Subject: Programmatic Categorical Exclusion (PCE) Concurrence Request
STPP 4-2(23) 54 STPHS 4-2(22) 55
Laurel Northeast 2002 Turn Lane – Laurel
Control Number 5186 Control Number 5304

STPHS 4-2(22)55
Laurel – 2002 Turn Lane
Control No. 5304

Subject: STPP 4-2(23)54
Laurel – NE
CN 5186

The Alignment & Grade Review Report (AGR) dated February 14, 2006 for this proposed project has been reviewed. Environmental Services has the following comments concerning this Report.

Vertical Profile Evaluation

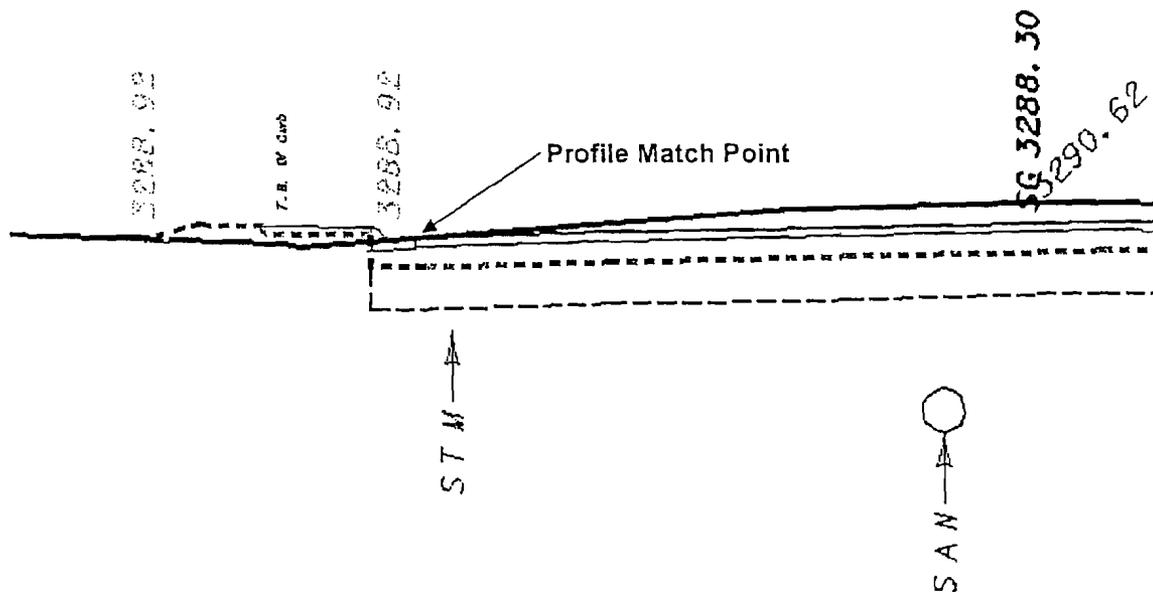
The revised profile was established by extracting the existing profile of the roadway along the lip of the new curb line and approximating a grade line to match the existing

roadway. The minimum grade of the revised profile is 0.12%.

Typical Section Widths

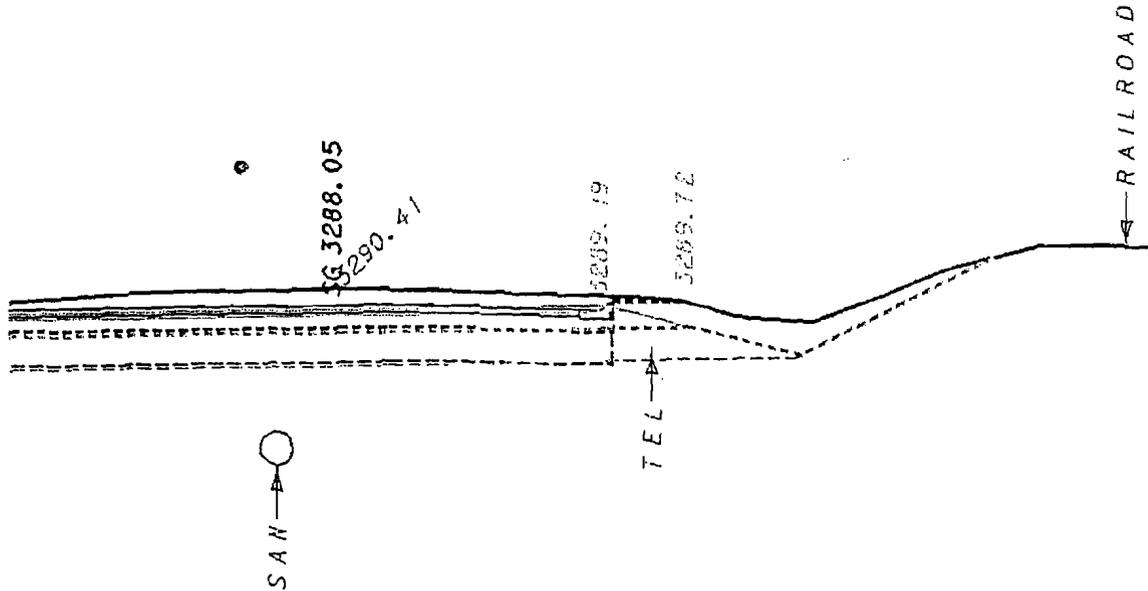
The typical section adjustments were determined by those in attendance at the Alignment and Grade review. The revised typical section consists of 11 foot travel lanes, a 12 foot two-way left-turn lane, and a 10 foot parking lane. The original typical consisted of 12 foot travel lanes, a 14 foot two-way left-turn lane, and a 12 foot parking lane, the overall reduction in width is 6 feet.

Since the Alignment and Grade Review meeting there have been additional discussions within the Department that the 11 foot travel lanes may not be acceptable with out substantial documentation supporting the reduced width.
